**STATEMENT OF RESPONSE TO AN BORD PLEANÁLA  
PRE-APPLICATION CONSULTATION OPINION**

**Proposed Strategic Housing Development  
on Lands at Mooretown,  
Swords, Co. Dublin**

**Applicant: Gerard Gannon Properties**

**April 2022**

Figure 2. Phasing of the Development (source: CCK Architects)

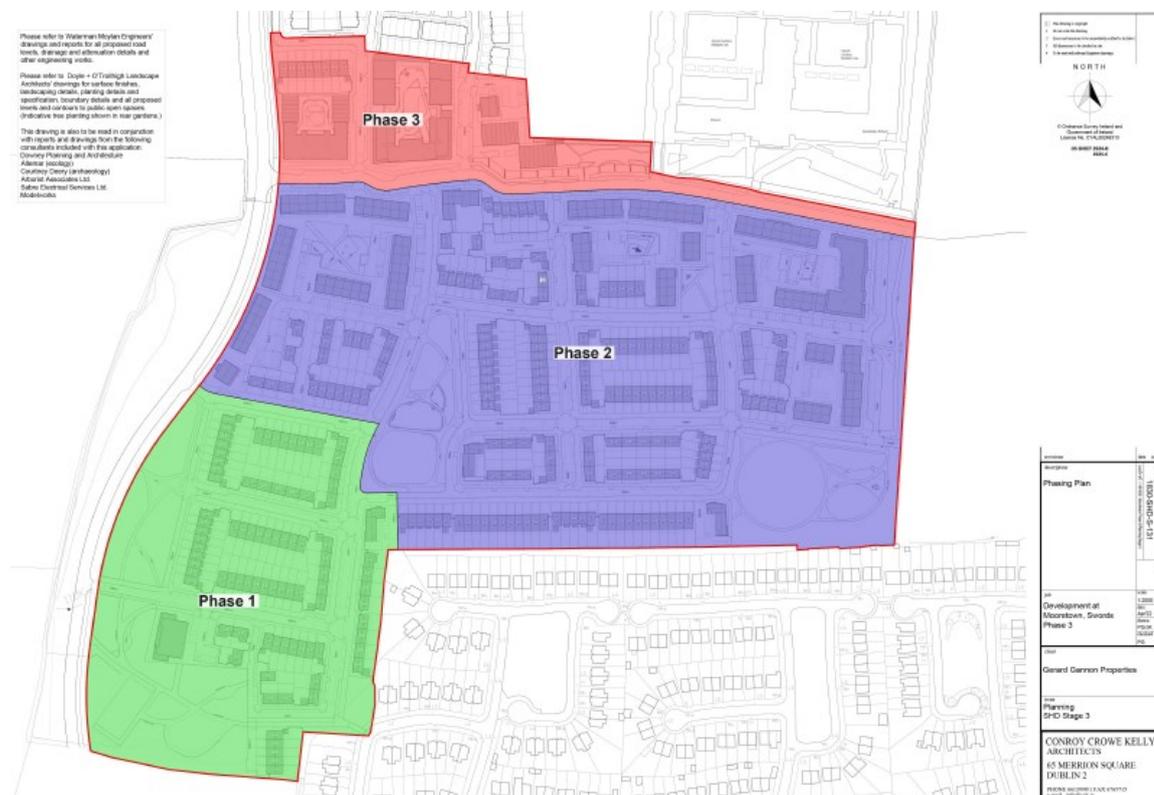
*"A phasing plan for the proposed development which includes the phasing arrangements for the delivery of the WDLR, public open spaces, surface water management proposals and Part V provision."*

It is submitted that a construction programme has not been developed at this stage, however, the development of WDLR, as submitted under Reg. Ref. F20A/0096, is to be constructed in two stages. Accordingly, this will include, in broad terms, the following: -

In relation to the stormwater storage tank on foul water network at Balheary Road, it is anticipated that the total construction period for the development will be approximately 3-4 months. Also, the proposed development is likely to be constructed in one phase, which in broad terms, it includes the following: -

In terms of delivery of the public open space, it is submitted that this would be completed in tandem with the phased construction of residential units, which is shown on the Figure below. For further details in this regard, please refer to the Allocation of Public Open Space in the Regional Park (drawing 1830-SHD-S-134), Public Open Space (drawing 1830-SHD-S-139), and Architects Phasing Plan (drawing 1830-SHD-S-131) prepared by CCK Architects as part of this SHD application. These drawings are suggested to be read in conjunction with the Architectural and Design Statement prepared by CCK Architects as well.

In relation to delivery of Part V, it is important to note that Part V dwellings are “pepper-potted” across the overall scheme and the Architects Phasing Plan (drawing 1830-SHD-S-131) captures a proportion of the 130 no. proposed Part V dwellings in each phase. Therefore, it is submitted that phase 1 will deliver 53 no. dwellings, Phase 2 will deliver 69 no. dwellings, and Phase 3 will deliver 8 no. dwellings. For further details in this regard, please refer to the Proposed Part V (drawing 1830-SHD-S-130), and Architects Phasing Plan (drawing 1830-SHD-S-131), prepared by CCK Architects. These drawings are suggested to be read in conjunction with Fingal County Council Part V Validation Letter, Part V Indicative Costings, and Planning Statement prepared by Downey as part of this SHD application.
